Discretionary Review Abbreviated Analysis HEARING DATE: JANUARY 30, 2020

Date: January 20, 2020
Case No.: **2018-014127DRP**
Project Address: **2643 31st Avenue**
Permit Application: 2018.0814.7292
Zoning: RH-1 [Residential House, One Family]
 40-X Height and Bulk District
Block/Lot: 2464A / 007
Project Sponsor: Weihong Yang
 PO box 390695
 Mountain View, CA 94039
Staff Contact: David Winslow – (415) 575-9159
David.Winslow@sfgov.org
Recommendation: **Take DR and Approve**

Discretionary Review Hearing
 Case Number 2018-014127DRP
 2643 31st Avenue

**Project Address – 2643-31st Avenue, SF
Request for Discretionary Review**

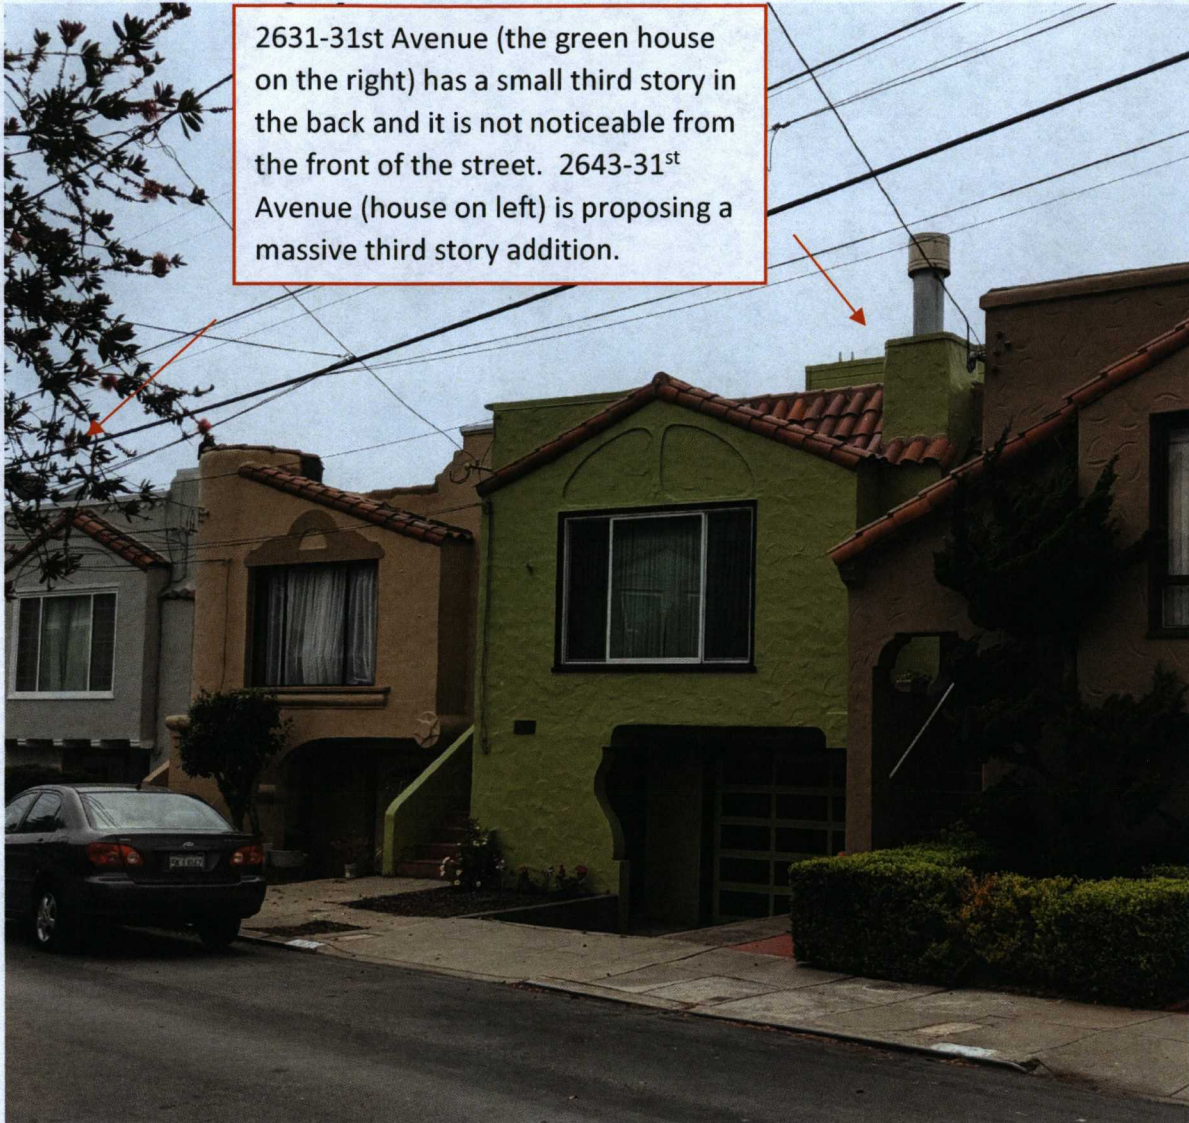
Examples of existing 3rd floor additions on 31st Avenue which are barely noticeable and roof lines.

2631-31st Avenue (the green house on the right) has a small third story in the back and it is not noticeable from the front of the street. 2643-31st Avenue (house on left) is proposing a massive third story addition.

**Project Address – 2643-31st Avenue, SF
Request for Discretionary Review**

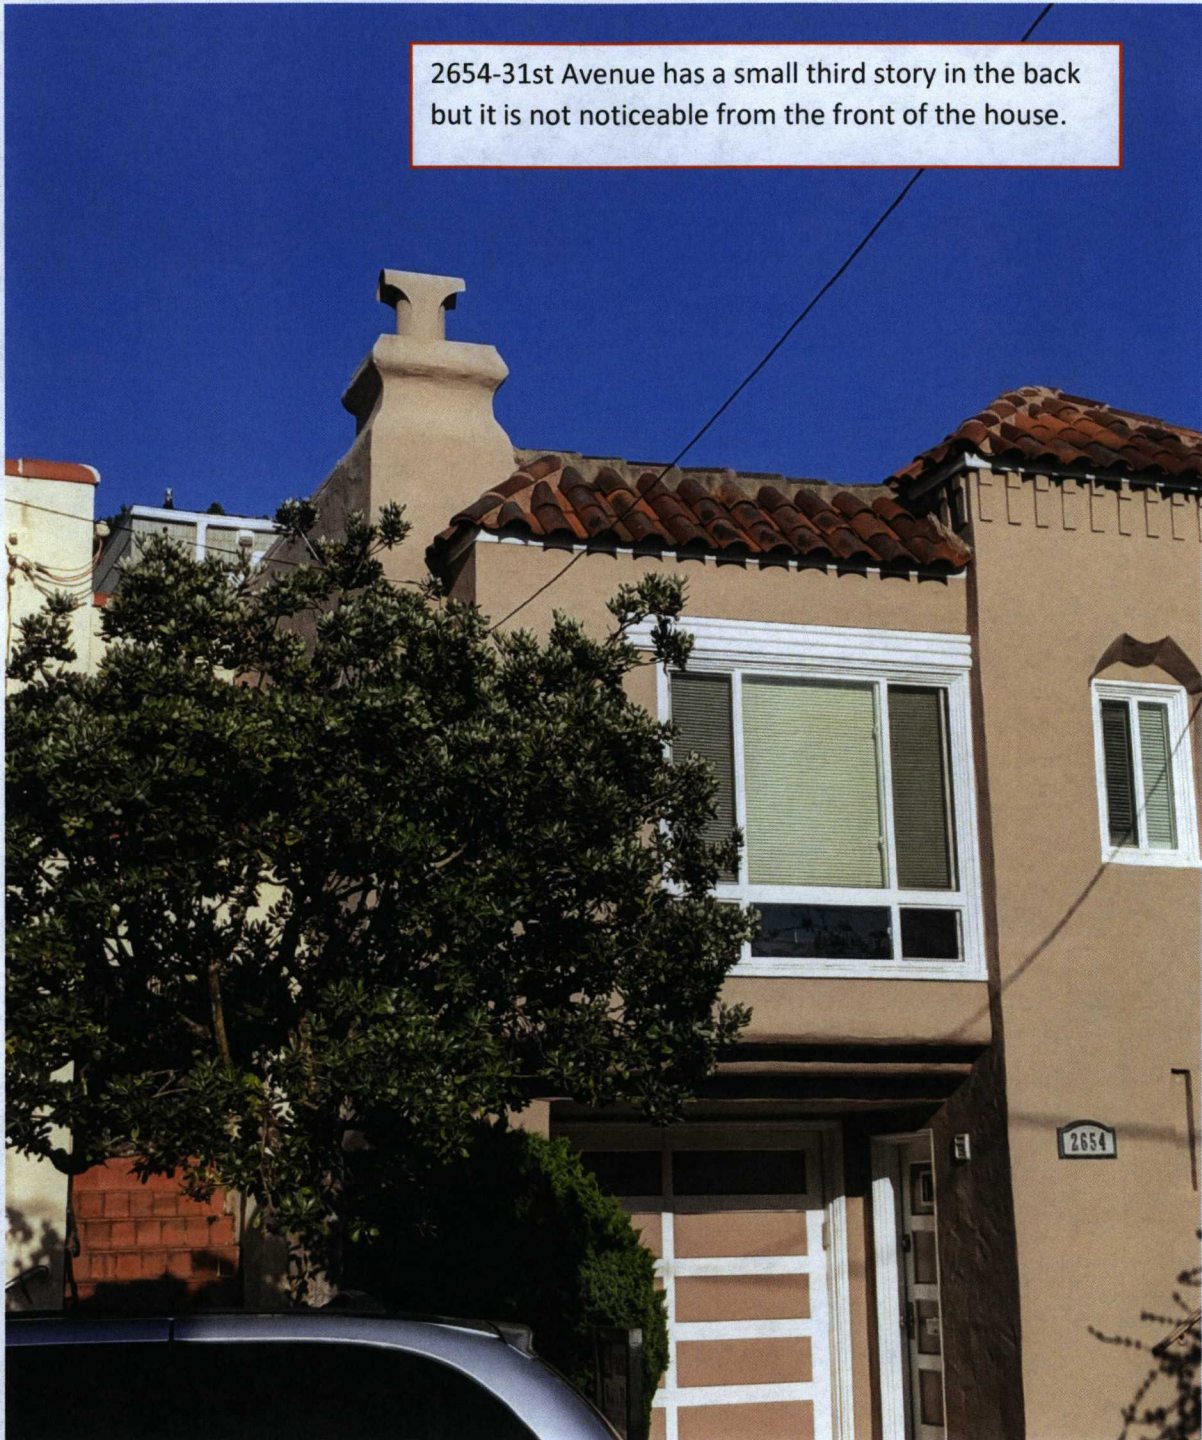
2654-31st Avenue has a small third story in the back but it is not noticeable from the front of the house.

**Project Address – 2643-31st Avenue, SF
Request for Discretionary Review**

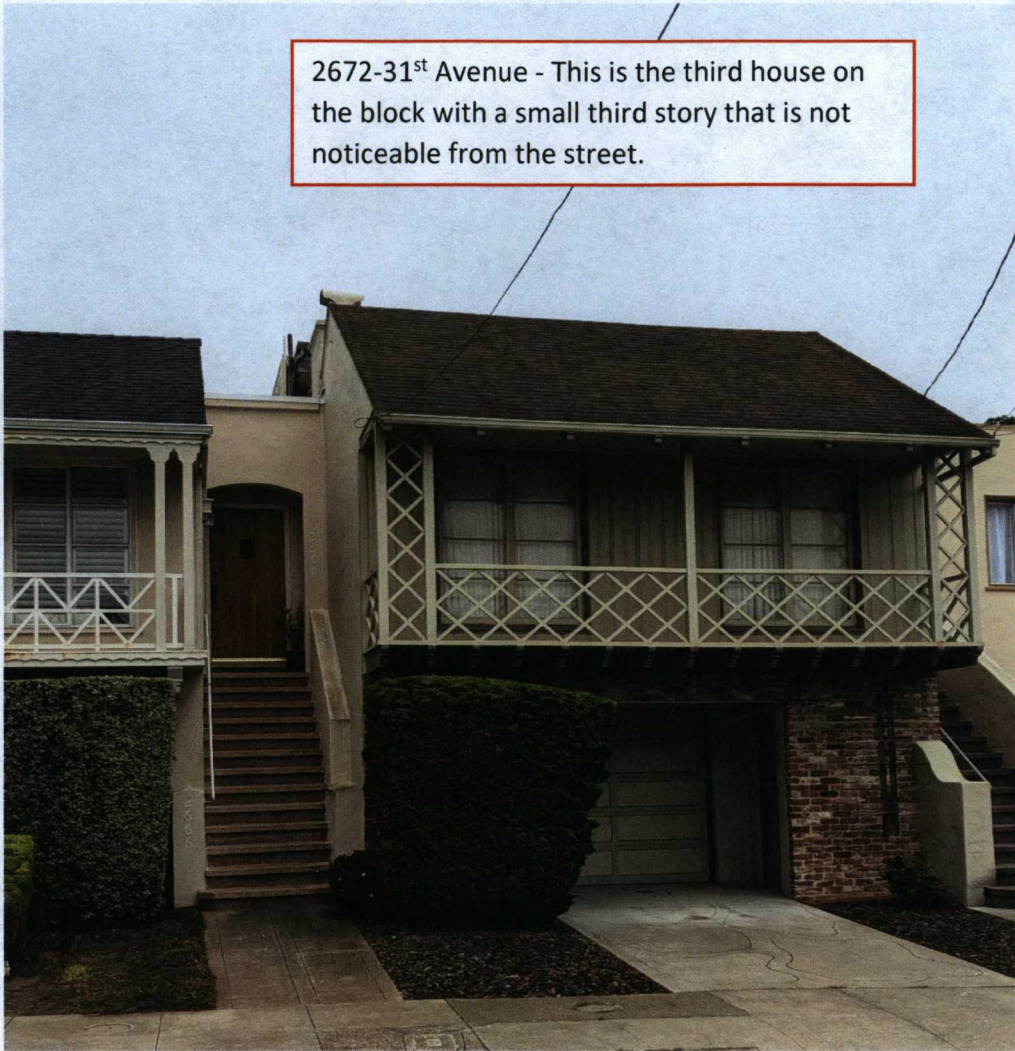
2672-31st Avenue - This is the third house on the block with a small third story that is not noticeable from the street.

Project Address – 2643-31st Avenue, SF
Request for Discretionary Review

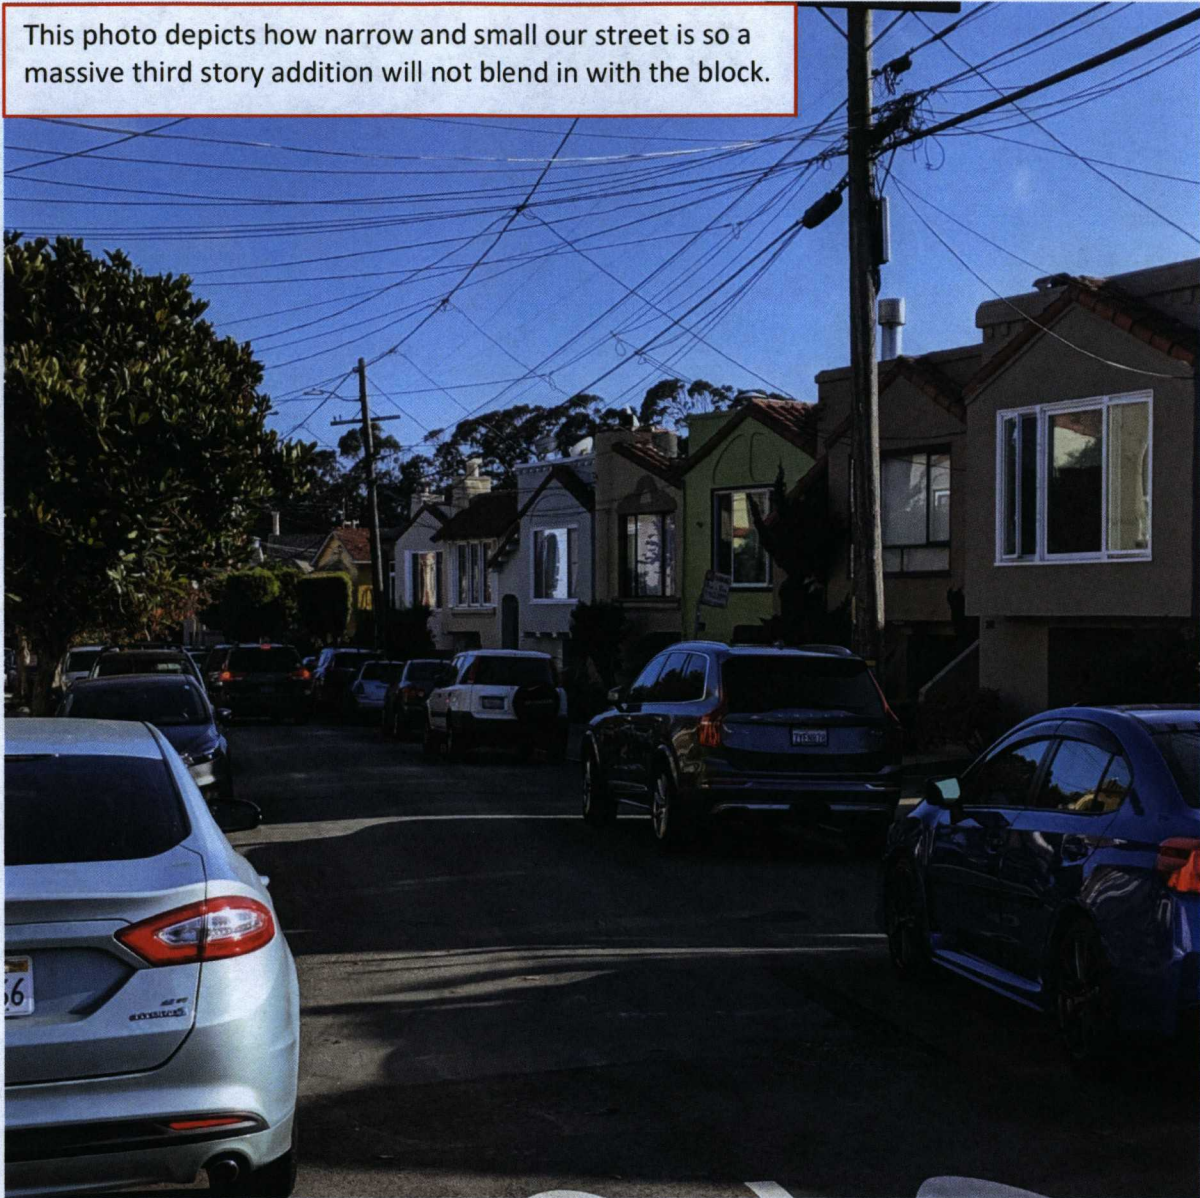
This photo depicts how narrow and small our street is so a massive third story addition will not blend in with the block.

Project Address – 2643-31st Avenue, SF
Request for Discretionary Review

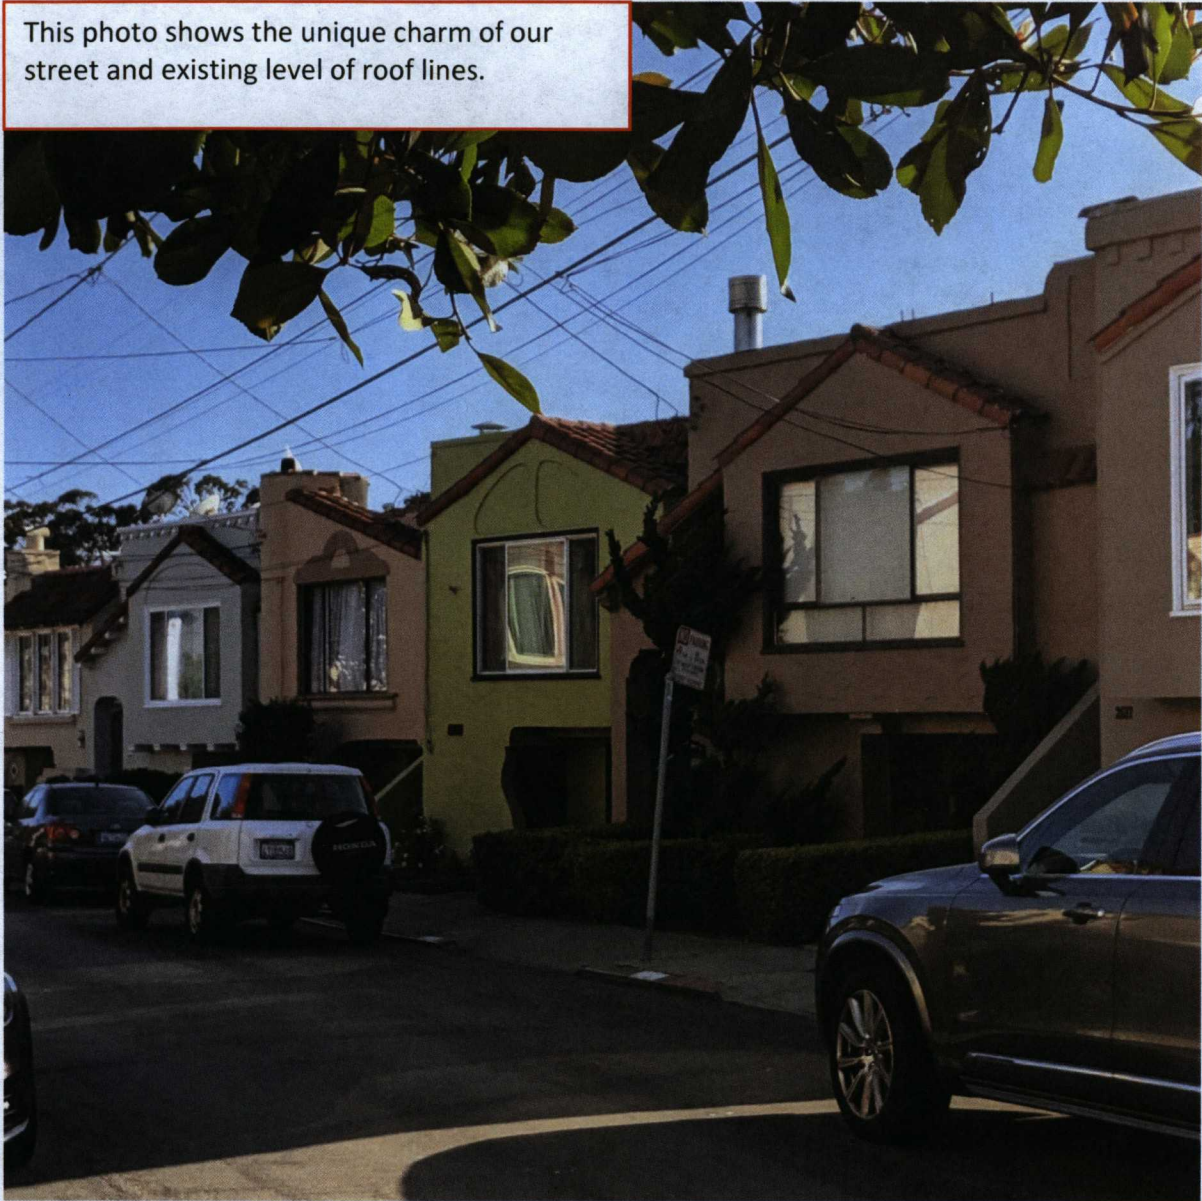
This photo shows the unique charm of our street and existing level of roof lines.

1 PROPOSED NORTH ELEVATION
 SCALE: 1/4" = 1'-0"

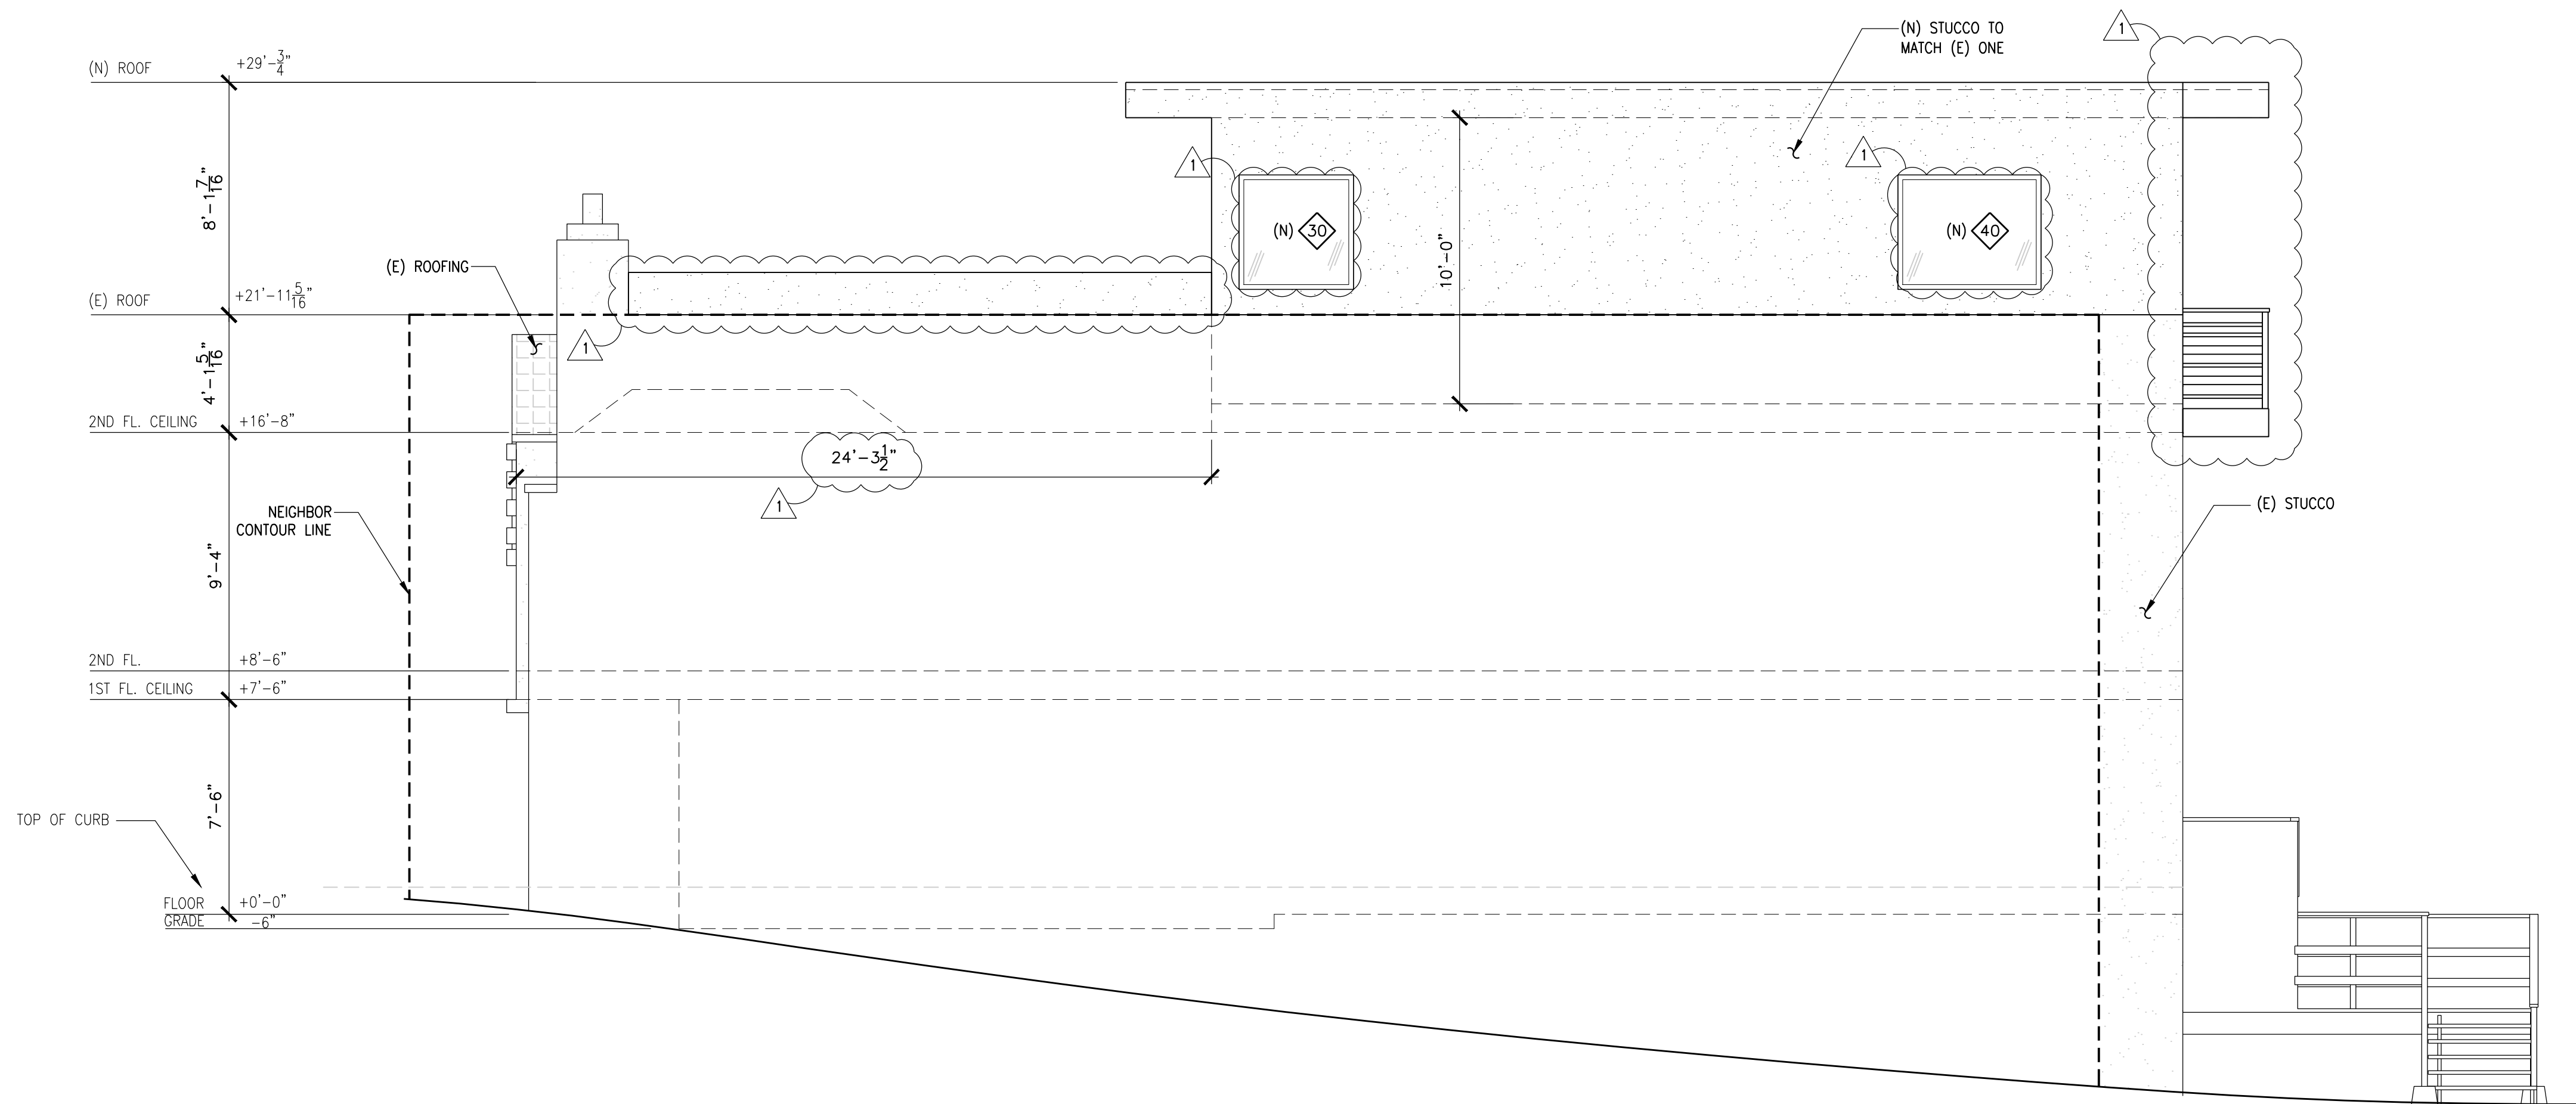
2. Though not within the purview of the Planning Department, the property line windows indicated on the North elevation of the proposed addition as 45-minute fire-rated assemblies should not be aluminum clad wood windows.
